Product Change Notice (PCN)

Subject: Carrier Tape dimension change for the listed Renesas WLCSP Packaged Products

Publication Date: 10/1/2020

Appendix A – Comparison of Carrier Tape Dimension

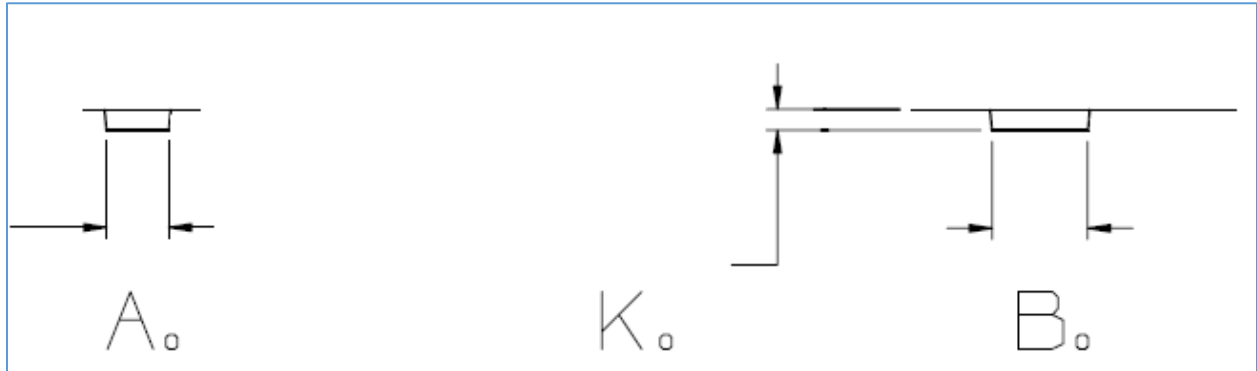
This notice is to inform you that Renesas will begin to use the new Carrier Tape for tape and reel packing of the listed Renesas WLCSP (Wafer Level Chip Scale Package) packaged products. The changes are not expected to affect the automated pick and place equipment used for board mount assembly operations. The differences are outlined in Appendix A.

Details	Existing Carrier Tape	New Carrier Tape	Summary
Width of pocket, A_0	1.51 ± 0.05 mm	1.50 ± 0.05 mm	Smaller
Length of pocket, B_0	1.51 ± 0.05 mm	1.50 ± 0.05 mm	Smaller
Depth of pocket, K_0	0.77 ± 0.05 mm	0.80 ± 0.05 mm	Larger
